## ON-SITE SEWAGE DISPOSAL SYSTEM HOWARD COUNTY HEALTH DEPARTMENT BUREAU OF ENVIRONMENTAL HEALTH

03-286460

ADDRESS: 3548 Lakeway Drive PROPERTY OWNER: Richard & Theresa Bond

PRE-CONSTRUCTION 1/5/04 To install a distribution box and two trenches off the drywell. (BB)

P520004

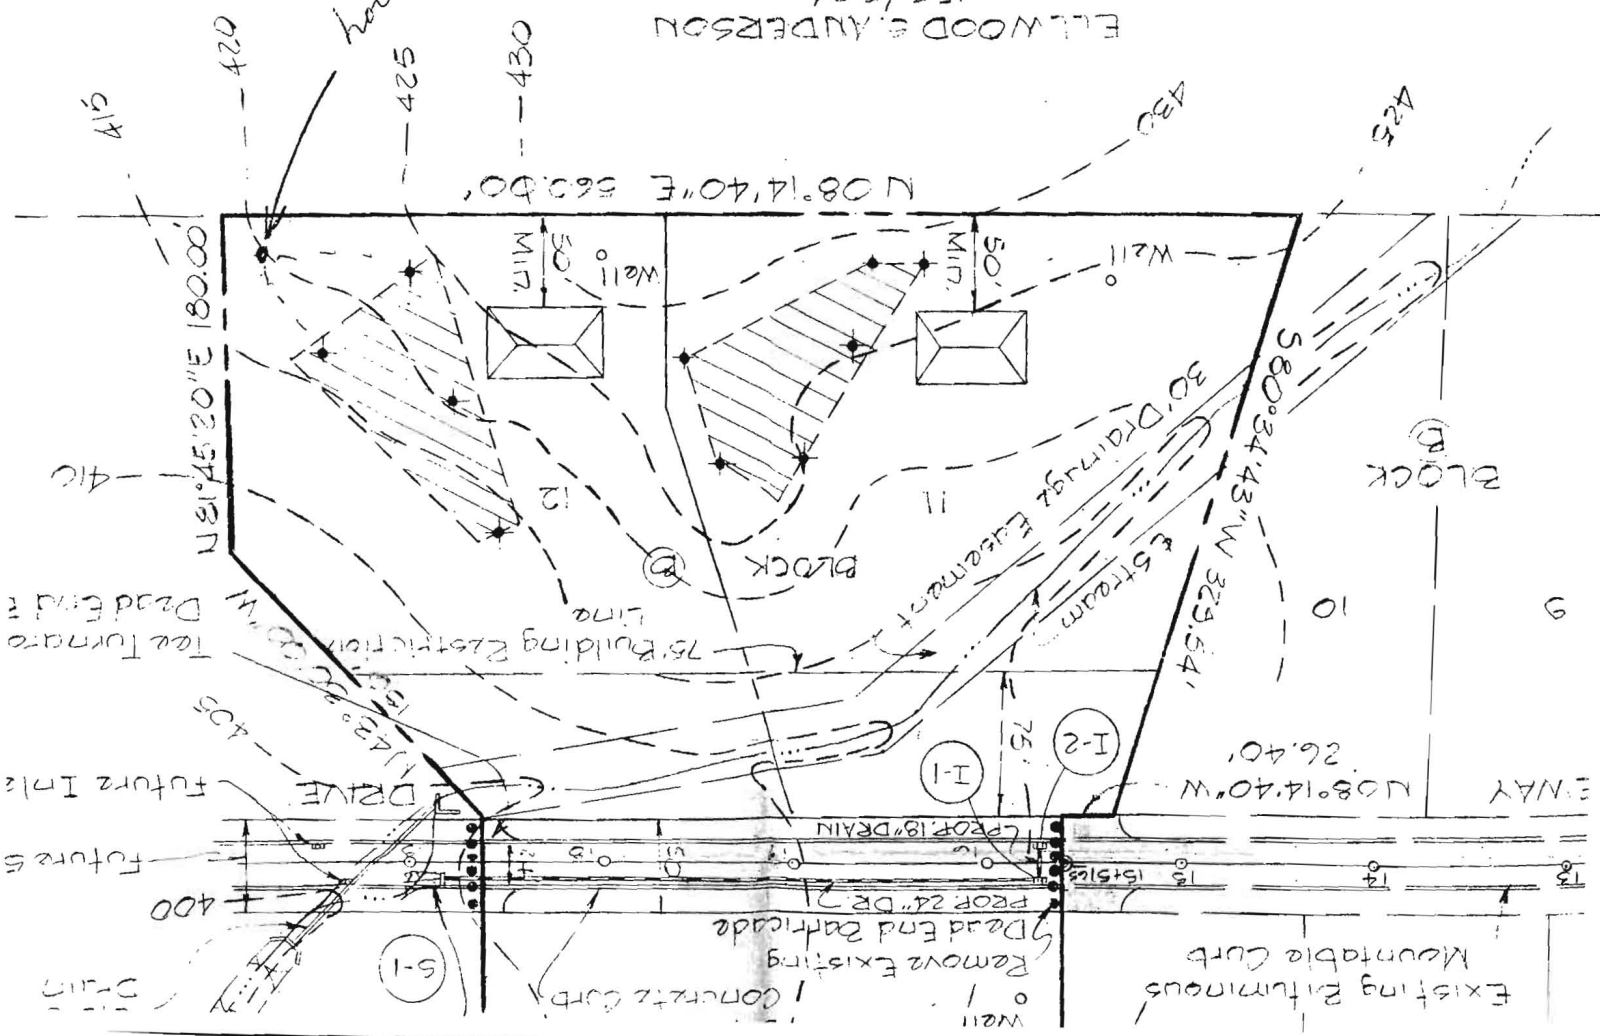
INSTALLATION 1/6/04 O.K. to cover everything. There should be enough area for an additional repair downhill of trenches ① and ②. (BB)

Copy signed Preliminary  
with mark-up (5/16/77)

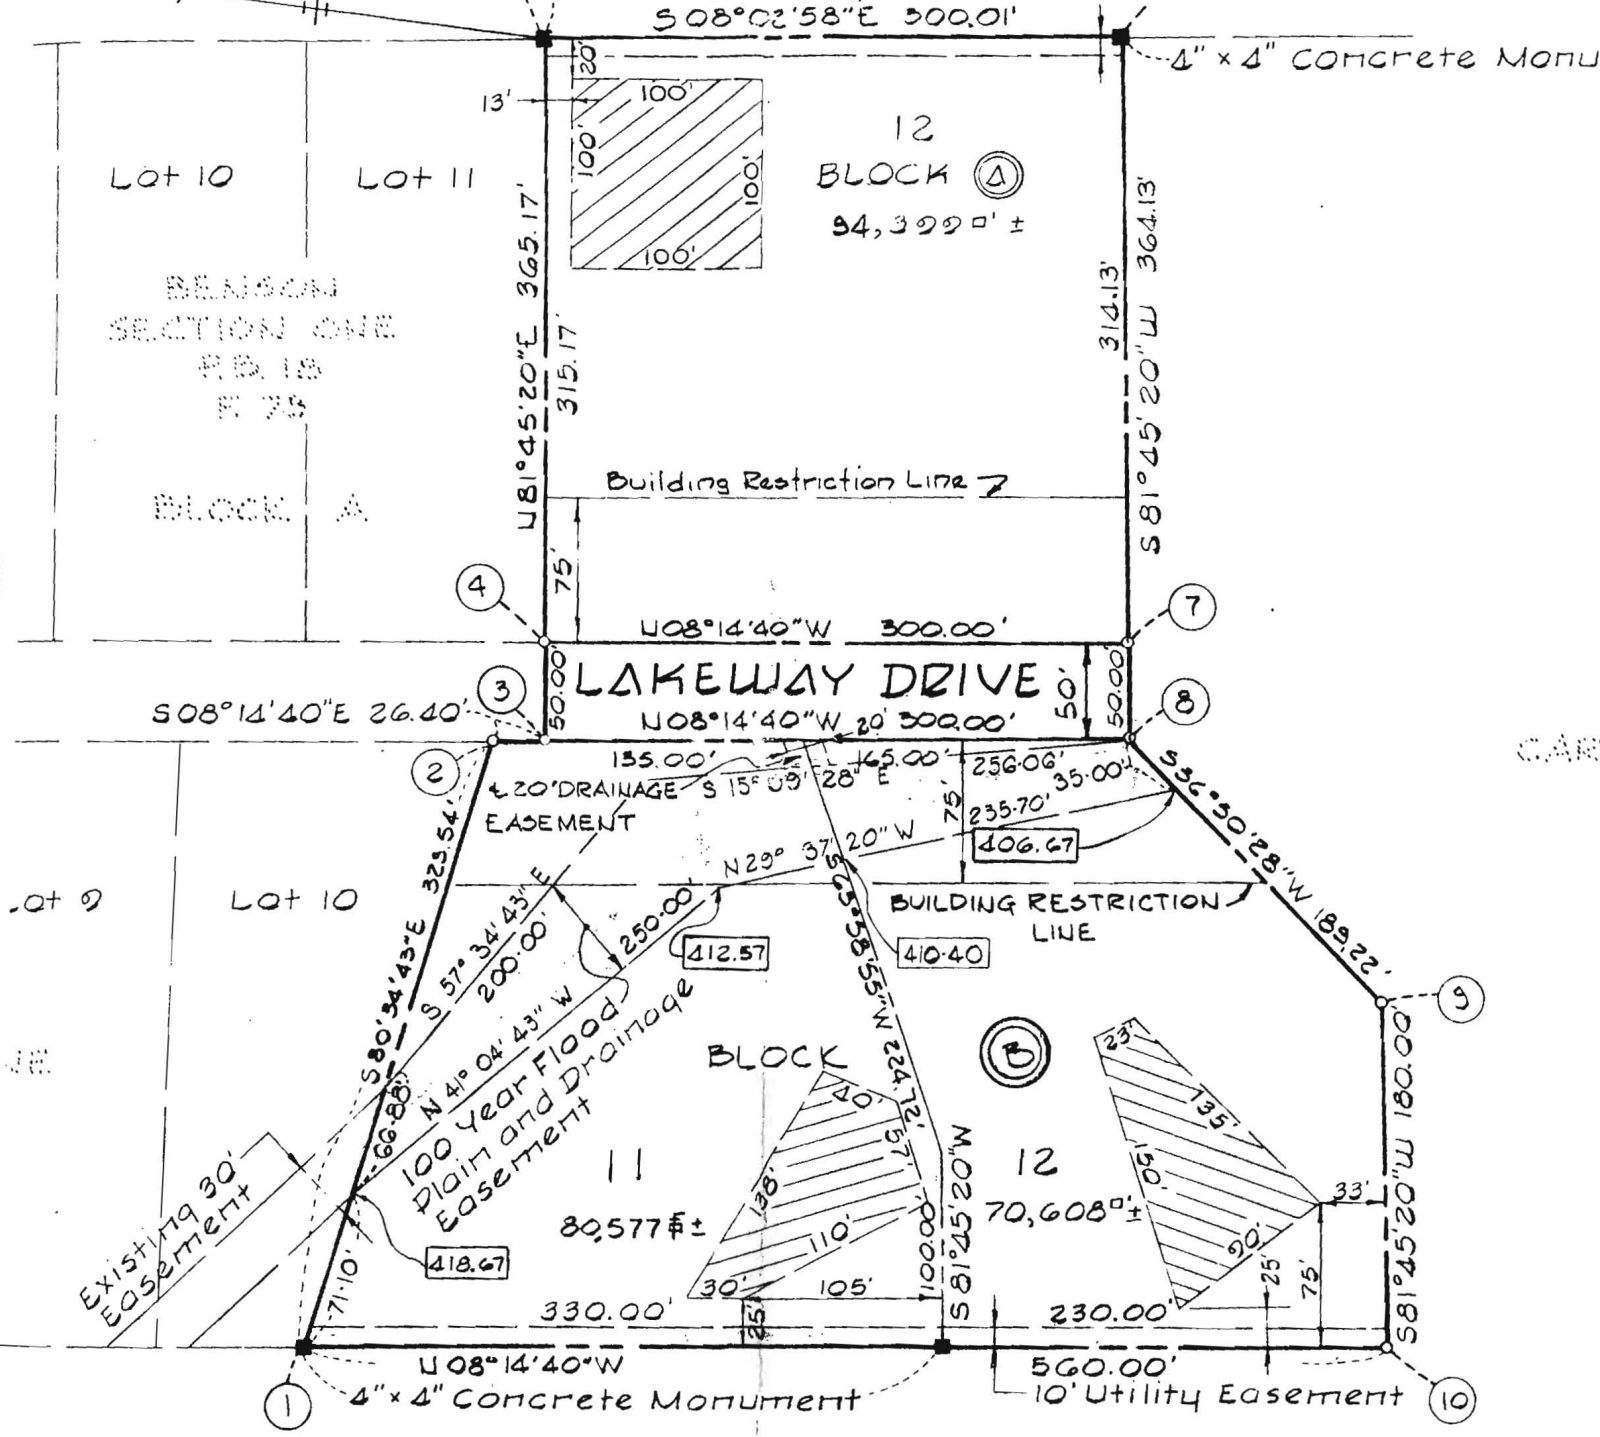
Adjust  
Septic Easement?  
due to Well location?

hole dug 5/16/77  
OK. w/m  
Bom
